**Schematic from TUSB4020BPHP Eval  
Module User Guide SLLU219-June2015**

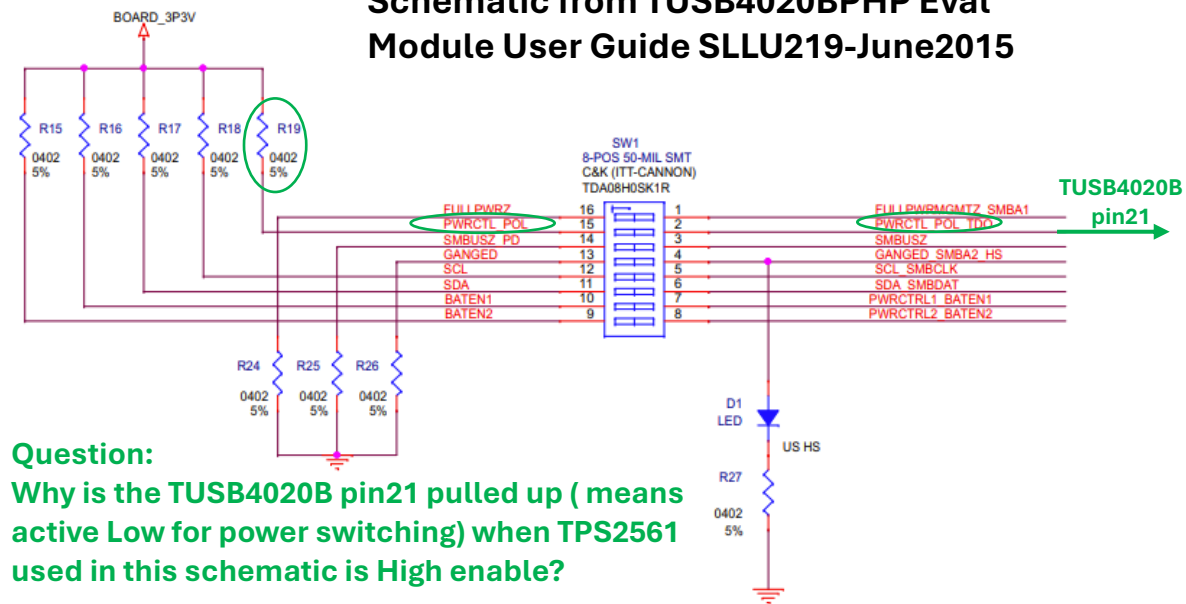
**Question:**  
Why is the TUSB4020B pin21 pulled up ( means active Low for power switching) when TPS2561 used in this schematic is High enable?
